Re: APS Career Enrichment Center

Requested for Permanent C. O. - Accepted Engineers Stamp Date 12/3/14 (J15D001)

DRAINAGE CERTIFICATION

RE: APS Career Enrichment Center (J-15/D001)

C-101

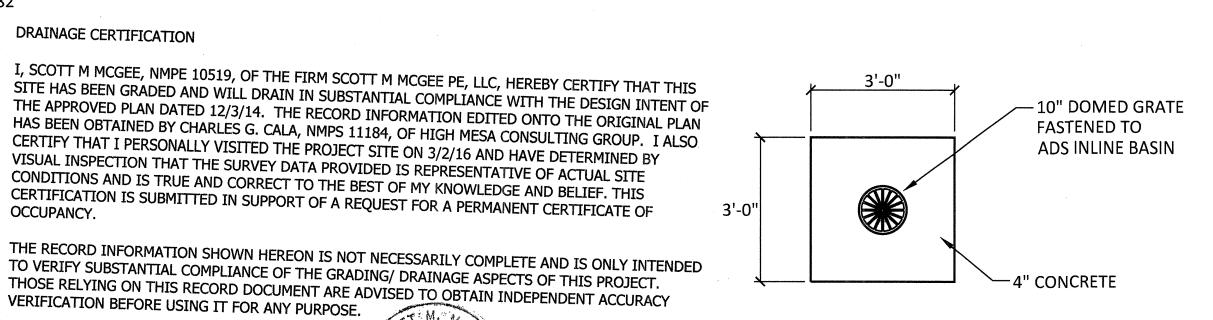
Thank you for your review comments of March 8, which have been addressed as follows:

- 1. The Contractor has installed the steel plate extension where the sidewalk was widened on the north side of the existing building.
- 2. The Contractor is available onsite to allow you access to the fenced off area to confirm the roof drain location.
- 3. The Contractor has addressed the valve box cover identified as a hazard.
